Prime Contract Change Order Number 001

Deschutes County Parole and Probation / Sheriff's Office WorkProject # 4120013-000

Parking Lot Expansion

This request is to ADD \$300,243 to the GMP Contract Amount.

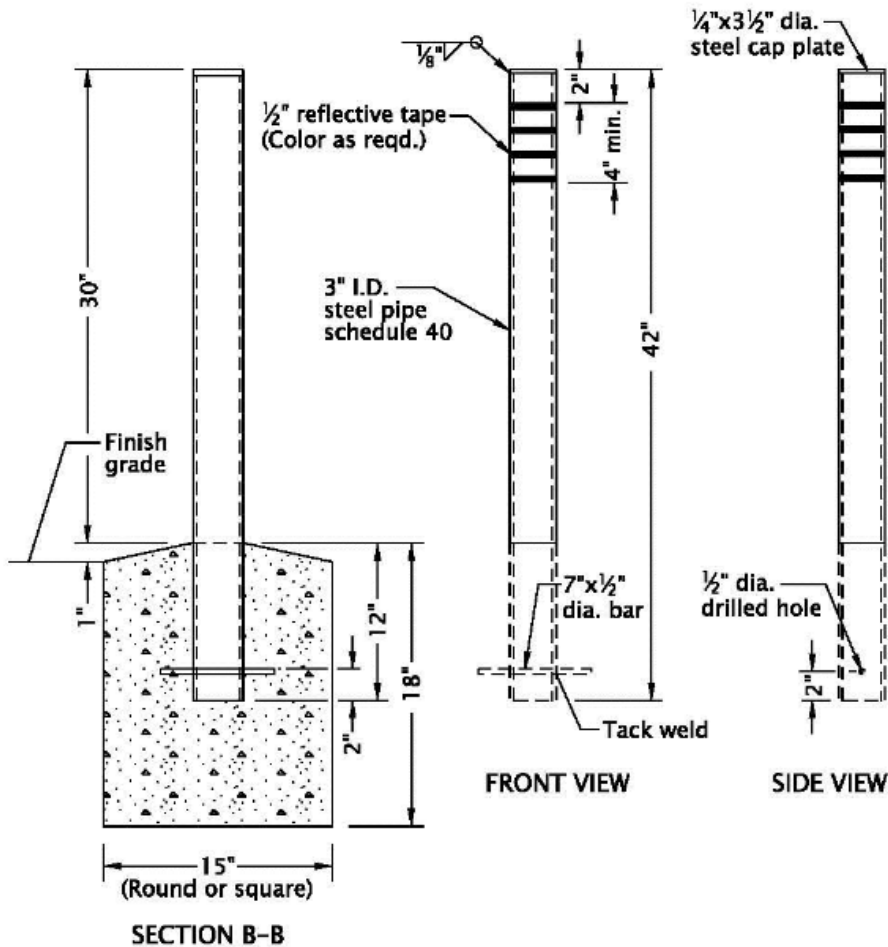
You want me to price as galv or yellow? Reason is we don't do color. But I can look at getting it painted or powdercoated

What would it cost to get 4 of these, we'll take care of the tape:

Would be \$830.00 supply for the 4 3in bollards supplied with caps and Galvanized \$207.50 each

3 PARKING STRIPING
SCALE: NOT TO SCALE

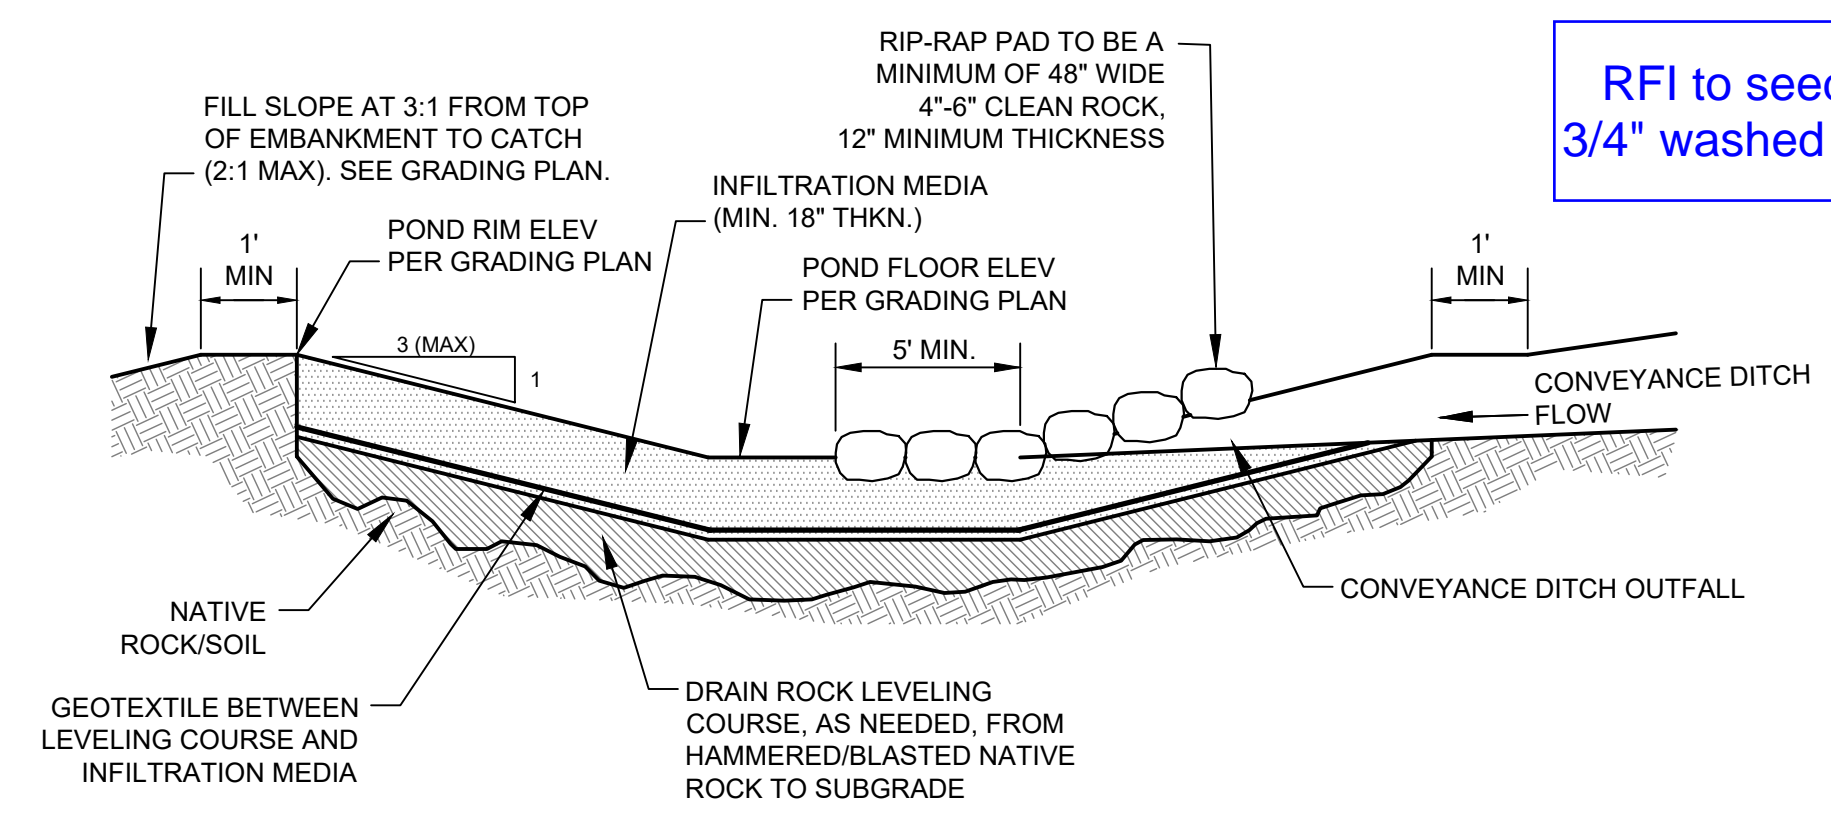
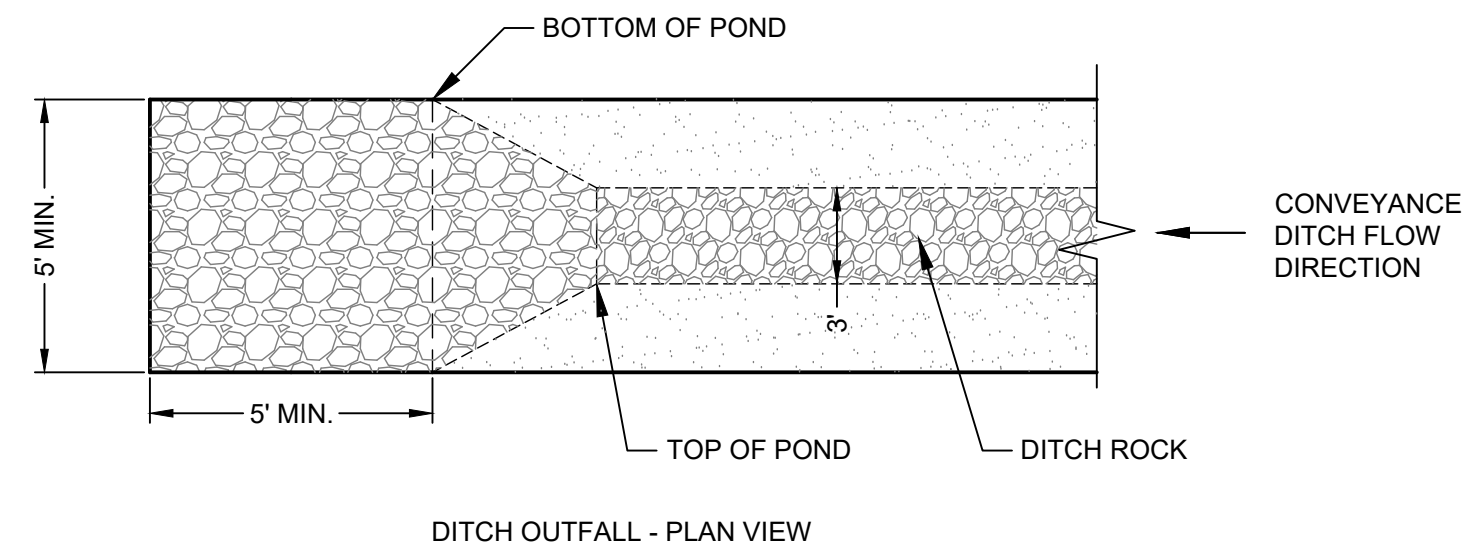
RFI to seed or add 3/4" washed to the top
